**Approval of "TOTO" Basin Mixer
(General Acceptance No. C20200581)**

Name of Manufacturer: TOTO Dalian Co Ltd
Country of Origin: the Mainland of China
Brand: TOTO
Details of Fitting: 1/2" Single lever basin mixer
Model: TLG10307H#XXX
(where "XXX" denotes the code of colour)
Body Markings: **TOTO**
Expiry Date: 25 July 2024

TLG10307H#XXX

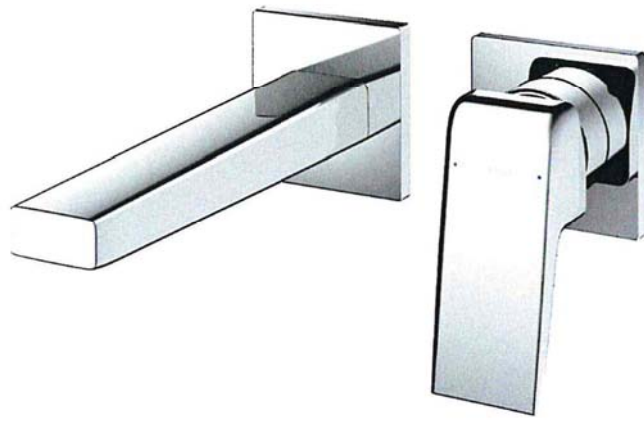
This Authority hereby permits the use of the above fitting in fresh water plumbing systems subject to full adherence to Waterworks installation requirements. In particular, you are required to draw your customers' attention to the following requirement-

"The cold water supply to the fitting shall be drawn from the same source that supplies the hot water apparatus so as to provide a balanced pressure and to obviate the risk of scalding in the event of a restriction or failure in the water supply."

A condition of this acceptance is that the fitting to be installed shall be replicas of the sample as certified by the testing agent mentioned above and without modifications. This acceptance may be withdrawn at any time if the standard of the fitting installed fails to meet that of the approved sample or if the fitting is found to be unsuitable for use in fresh water plumbing systems.

This acceptance is only applicable to the main body of the fitting, unless otherwise specified.
